RE: SSAB Report; Molycorp case

Report

Molycorp Decommissioning Plan

Report
Site Specific Advisory Board
under the auspices of the
Nuclear Regulatory Commission for
the Molycorp Decommissioning Plan
Washington, Pennsylvania

Cell Information

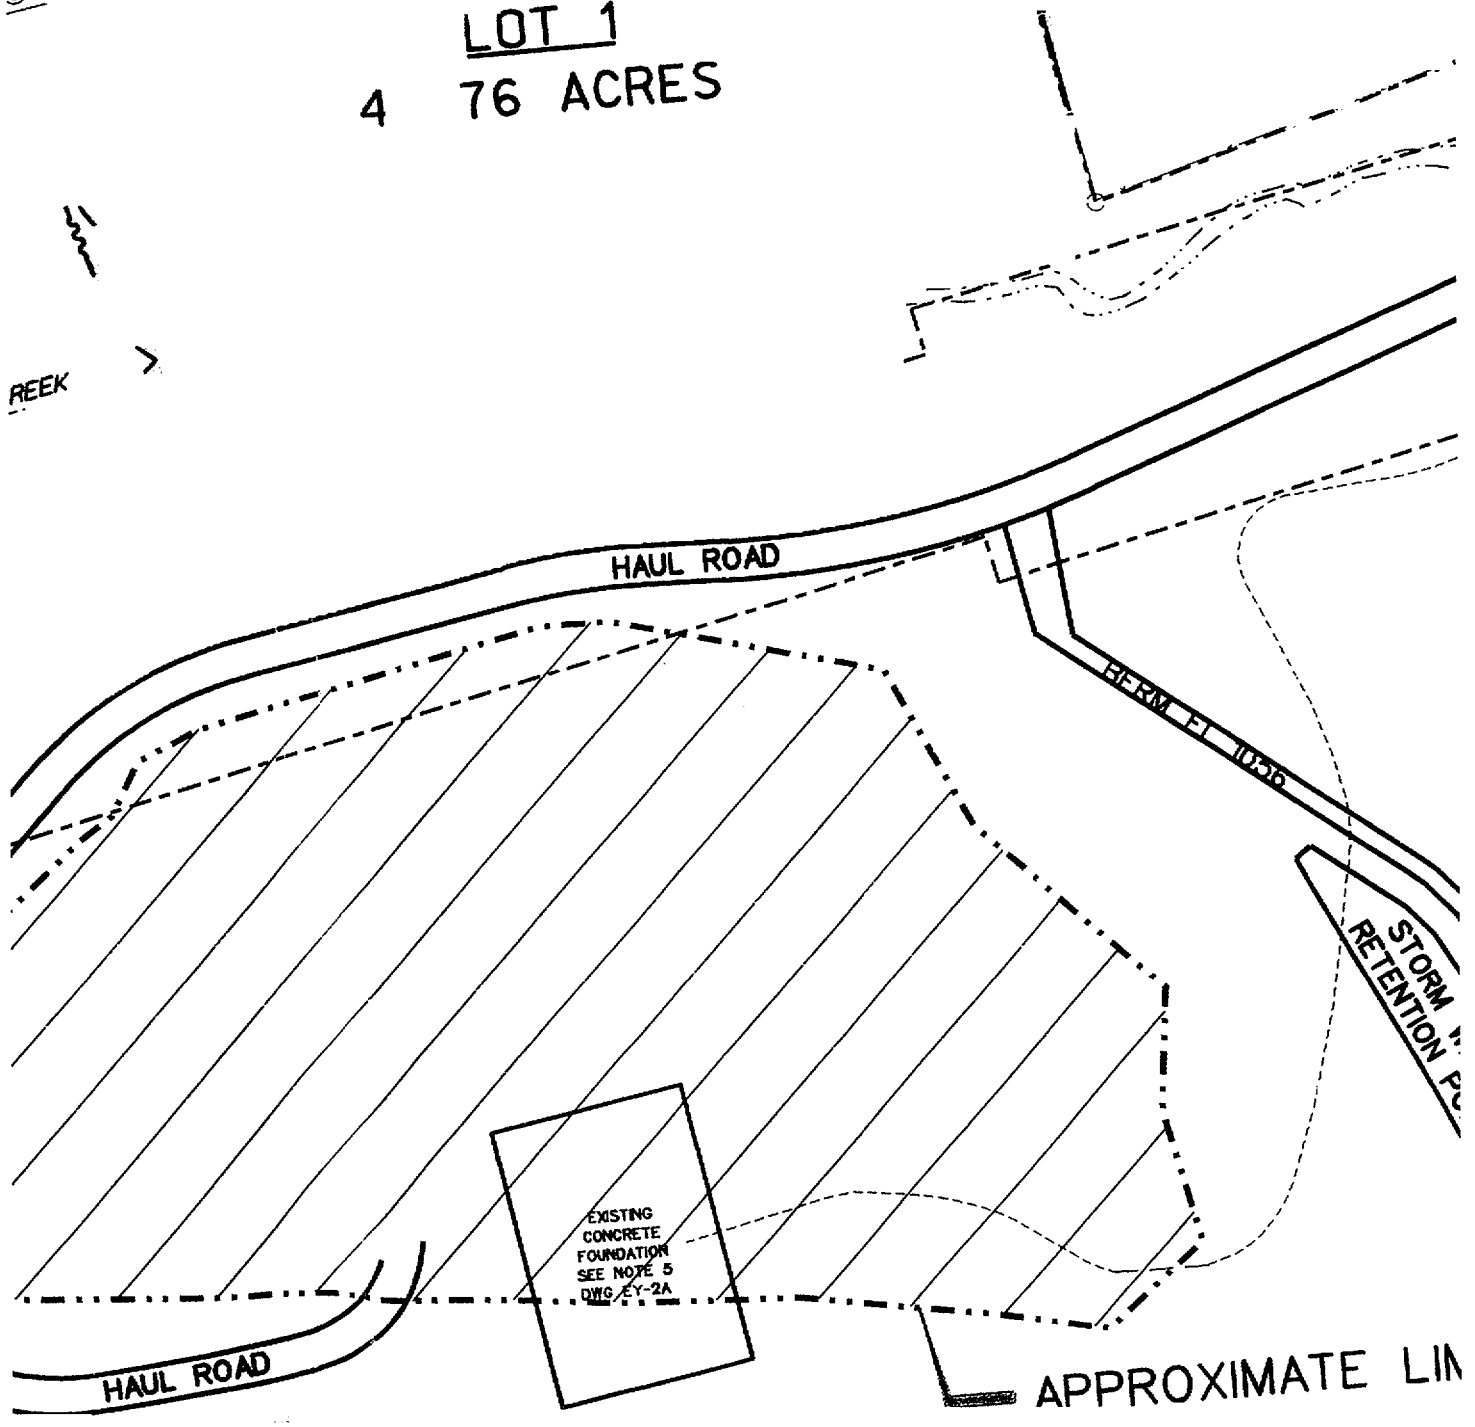
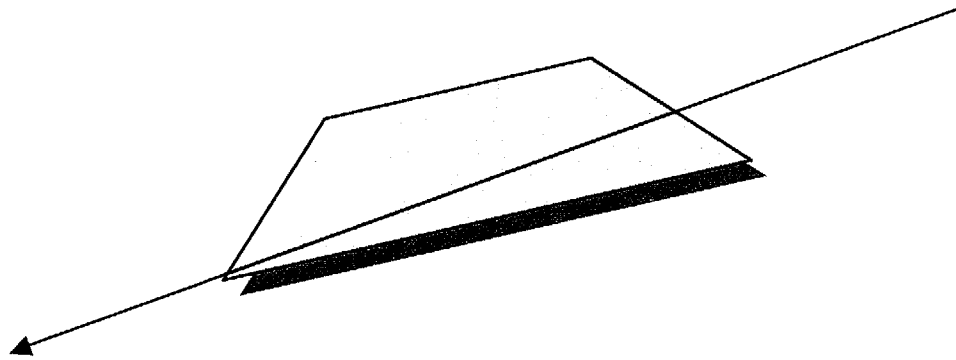
- Dimensions 700x300
- Slope 3 to 1 grade
- 120,000 to 125,000 cubic yards of radioactive material
- Mixed waste site
- 5 acres

SLOPE 3to1

1. The heavy weight mass of the Thorium slag on a 3 to 1 slope of the north side of the site will cause slippage, thus exposing the atmosphere to the radiation, or contaminating the test wells.
2. Similar results could occur due to fresh water springs or mine subsidence.
